central
 subway

CS Memorandum No. 1286

То:	Distribution
From:	Susan MacKenzie, Document Control Manager
Date:	November 13, 2012
Reference:	Project No. M544.1, Contract No. CS-149 Task No. 1-8.02, Change Control
Subject:	Configuration Management Board Meeting No. 100

CMB Meeting Minutes #100

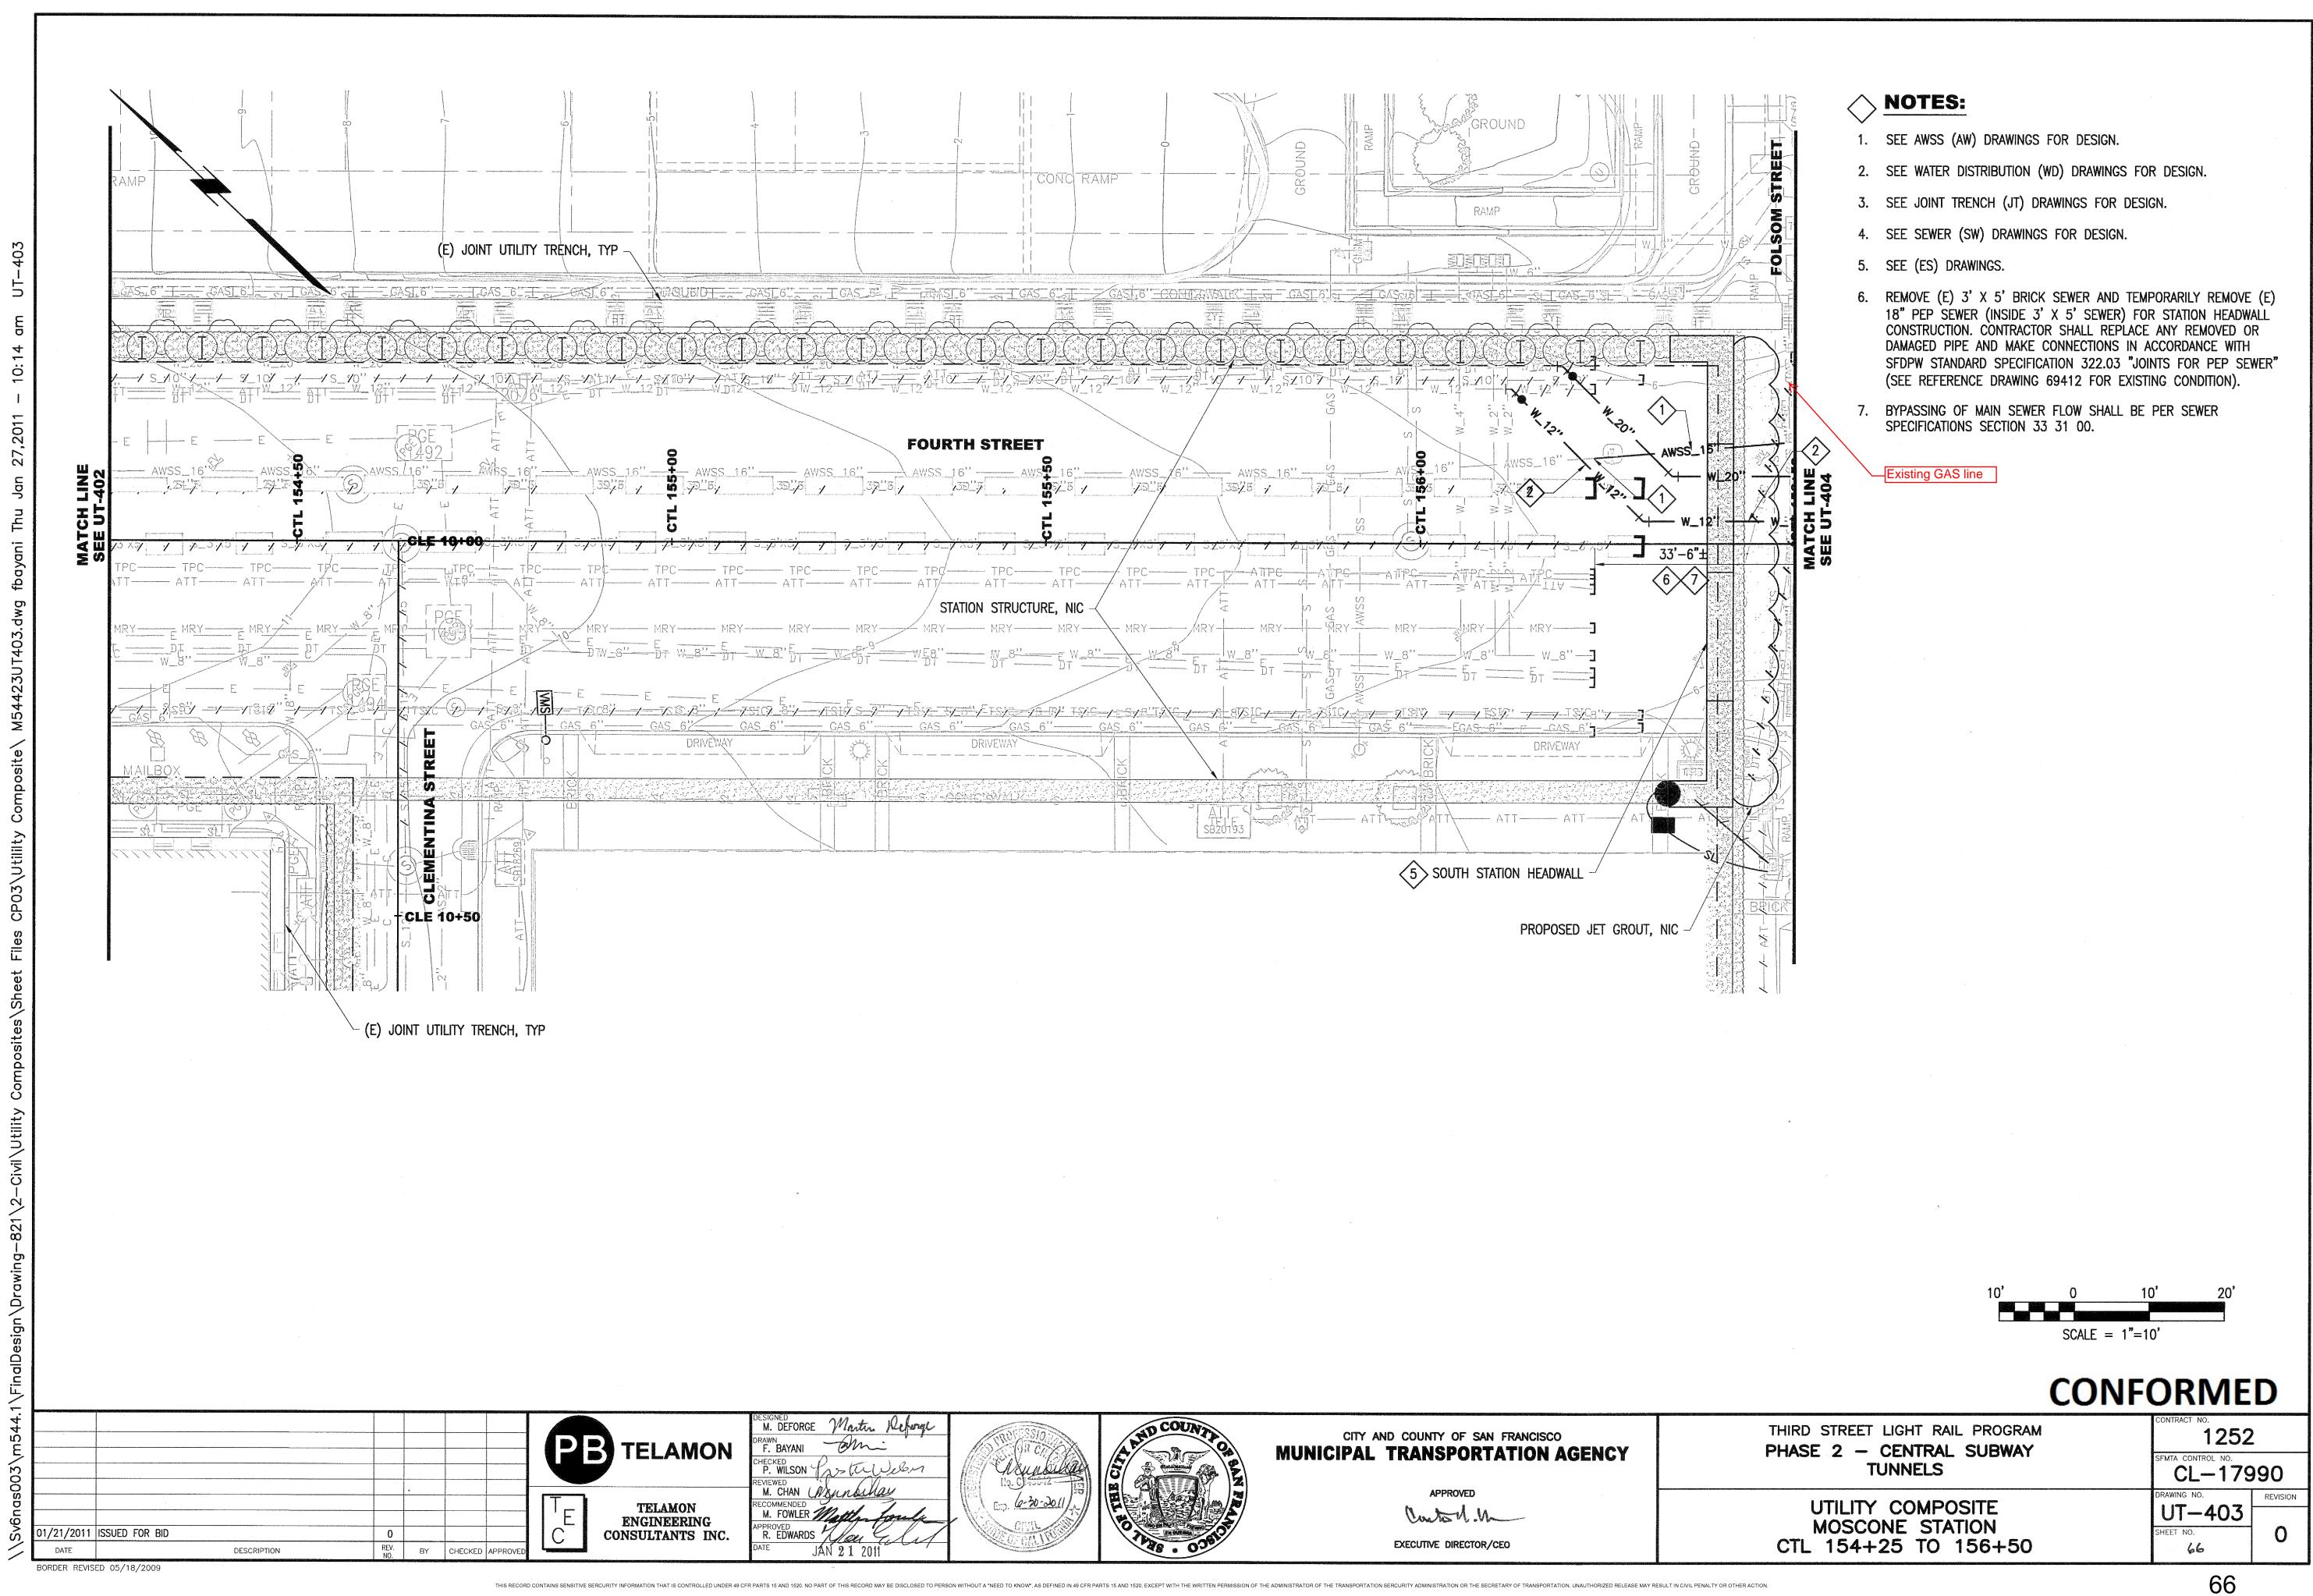
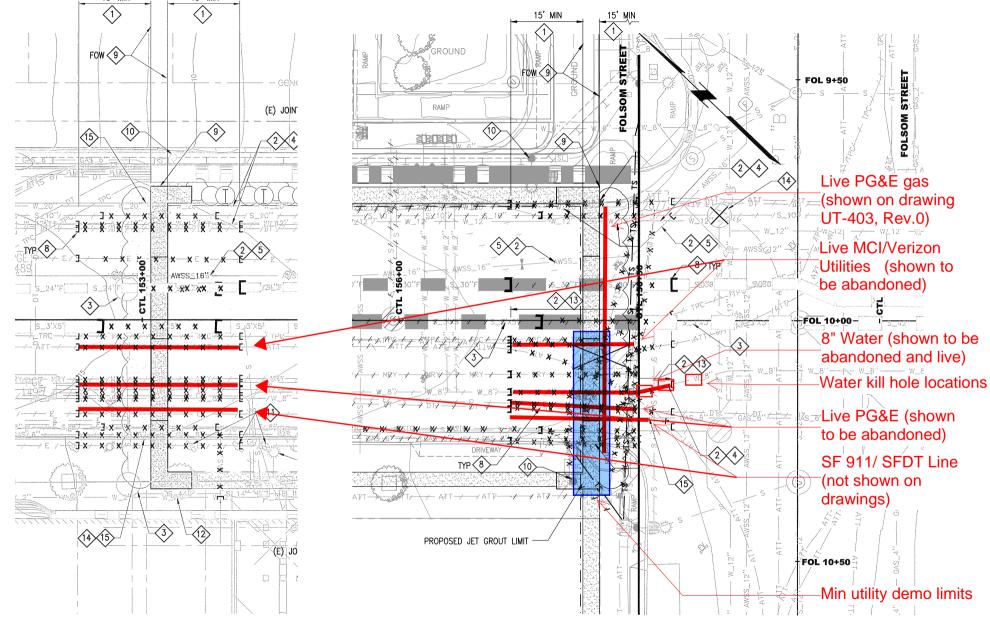
18" PEP SEWER (INSIDE 3' X 5' SEWER) FOR STATION CONSTRUCTION. CONTRACTOR SHALL REPLACE ANY REA DAMAGED PIPE AND MAKE CONNECTIONS IN ACCORDAN SFDPW STANDARD SPECIFICATION 322.03 "JOINTS FOR (SEE REFERENCE DRAWING 69412 FOR EXISTING COND

BYPASSING OF MAIN SEWER FLOW SHALL BE PER SEW SPECIFICATIONS SECTION 33 31 00.

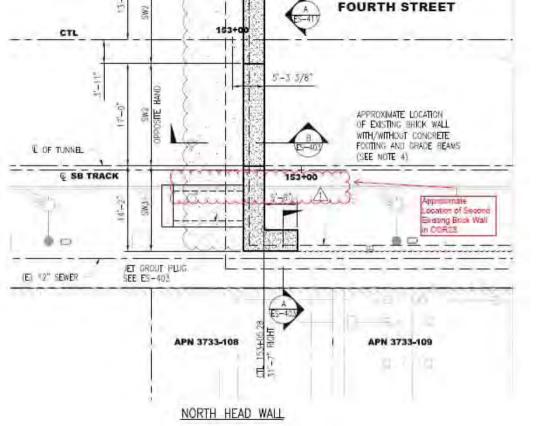
Facts: BIH's subcontractor, Synergy Project Management (SPM), uncovered a buried brick wall, beneath the west curb at the location of the north headwall for Moscone Station, not shown in the contract documents, but in the vicinity of a buried brick wall that was shown on the contract drawings. The Contractor submitted RFI #114 on 7/10/12 with notification of the discovery of the 18-24" thick brick wall of unknown depth. A lump sum agreement was made on July 11, 2012 between SFMTA and BIH/Synergy to remove the buried brick wall and it was removed by July 18, 2012.

Rationale for COR: Additional costs were incurred by the Contractor for differing site conditions involving removal of a buried brick wall not shown in the contract documents, that interfered with construction of the north headwall for Moscone Station.

Justification: The contract documents do not show the second existing buried wall at the location of the north headwall for Moscone Station. The brick wall could not be excavated along with the headwall excavation because of the anticipated slurry wall installation methods for the headwall. Removal of the buried wall was required prior to installation of the headwall.
